Subject: Amended MHI's Response to US-APWR DCD RAI No.584-4468 Revision 0 (SRP 09.02.02)

Amended Responses to Request for Additional Information
No. 584-4468, Revision 0

RAI NO.: NO.584-4468 REVISION 0
SRP SECTION: 09.02.02 – Reactor Auxiliary Cooling Water Systems
APPLICATION SECTION: DCD Tier 2 Section 9.2.7
DATE OF RAI ISSUE: 05/10/2010

Figure 2.7.3.6-1 Non-Essential Chilled Water System

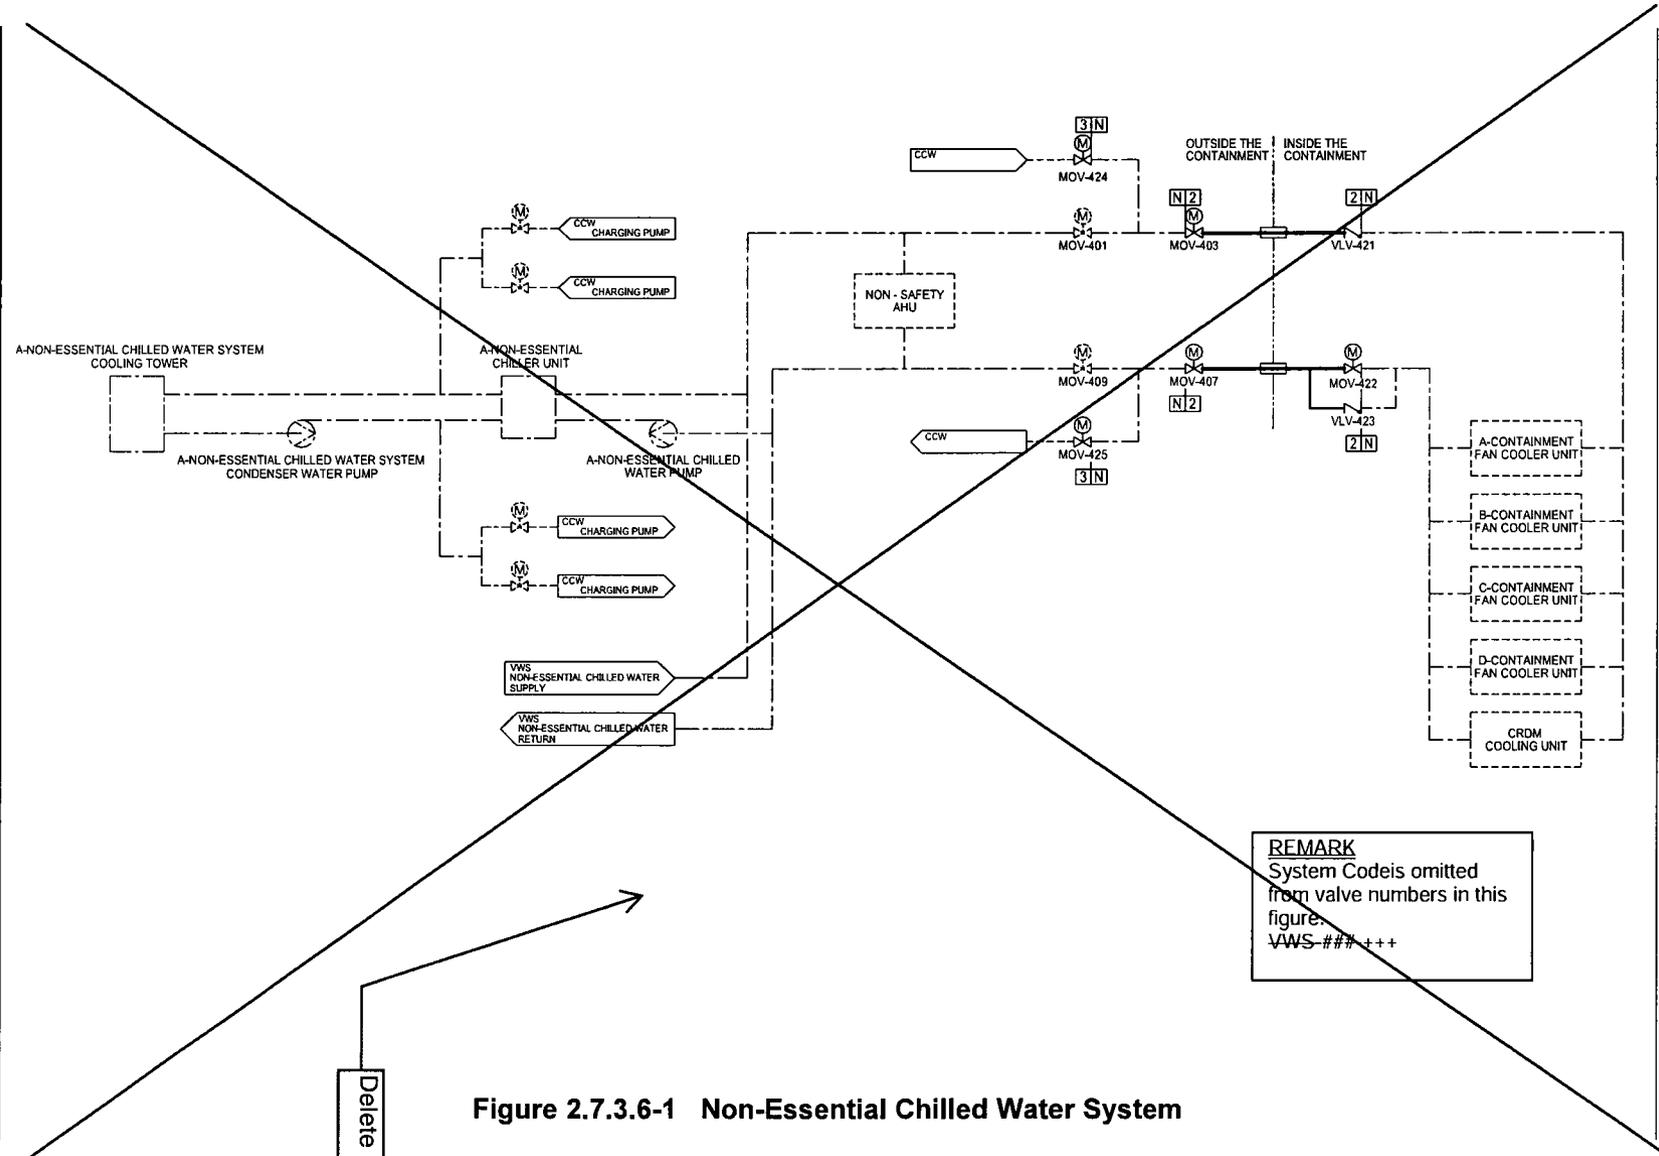
1. Review DCD to ensure all Tier 1 information is provided in Tier 2, including table and figure content.
2. During a review of DCD Rev. 2, the staff noted that Section 9.2.7.5.1 specifies the compression tanks contain MCR alarms, but Table 2.7.3.5-4 seems to indicate that the tanks do not have any MCR/RSC Alarm. The applicant is asked to resolve this inconsistency.
3. In addition, provide a reason why non-ECWS Tier 1 Section 2.7.3.6.1 does not include valves VLV-421/422 and MOV-424/425 in a table similar to Table 2.7.3.5-2 with the pertinent ITAAC.
4. Table 2.7.3.6-2 should include valves VWS-MOV-424, -425, which are Seismic Category I.

Therefore, Tier 1 DCD Section 2.7.3.6 will be revised to delete Tables 2.7.3.6-1, -2, and Figure 2.7.3.6-1 since they are no longer required to be included in the DCD.

Tier 1 DCD Section 2.7.3.6 will be revised to delete Tables 2.7.3.6-1, -2, and Figure 2.7.3.6-1. Tier 1 DCD Section 2.7.3.6.1 will be revised as follows:

Delete Figure 2.7.3.6-1
